Subject: Fuel Leak Case No. RO0002996 and Geotracker Global ID T10000000885, Earl Thompson Property, 316 38th Street, Oakland, CA 94611 – Work Plan Review

Alameda County Environmental Health (ACEH) staff has reviewed the fuel leak case file for the above referenced site including the recently submitted work plan entitled, "Revised Workplan for Additional; Soil and Groundwater Investigation," dated November 20, 2009 (Revised Work Plan). The Revised Work Plan proposes eight direct-push soil borings.

Attachment A: Sampling Locations

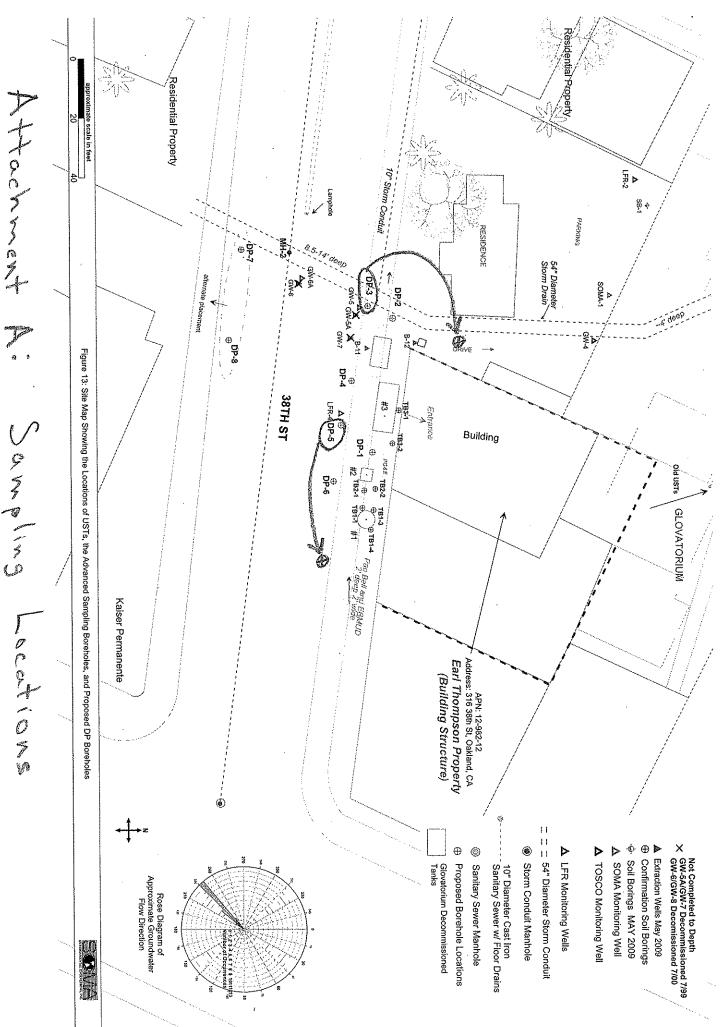
- 1. **Base Map.** The revised base map showing the locations of previous soil borings, existing and historic monitoring wells, former nearby USTs associated with the Glovatorium site, revised property boundaries and building configurations, and sanitary sewers and storm conduits is acceptable.
- 2. **Proposed Boring Locations.** We request some modification to two proposed boring locations in order to provide better definition of the extent of contamination to the west and east of the former tanks. Suggested boring locations are shown on an attached figure (Attachment A). Please also see the request for boring locations to the north inside the building.

- 3. Deleted Boring Locations Inside the Building. The previous Work Plan dated August 3, 2009, included a total of six proposed limited access direct push soil borings inside the building. These proposed borings inside the building were deleted from the Revised Work Plan dated November 20, 2009 although no technical comments were made by ACEH regarding the proposed borings. We request that you review and provide information on the current or former locations of piping, dispensers, and/or equipment inside the building that may have been used to transport, dispense, or otherwise use the contents of the USTs. Based on the locations or former locations of these features and review of the existing data, which shows elevated concentrations of TPH as gasoline and TPH as Stoddard solvent in soil and groundwater immediately adjacent to the building, we request that you propose limited access direct push soil borings inside the building(s). Please present the requested information and proposed boring locations in the Revised Work Plan requested below.
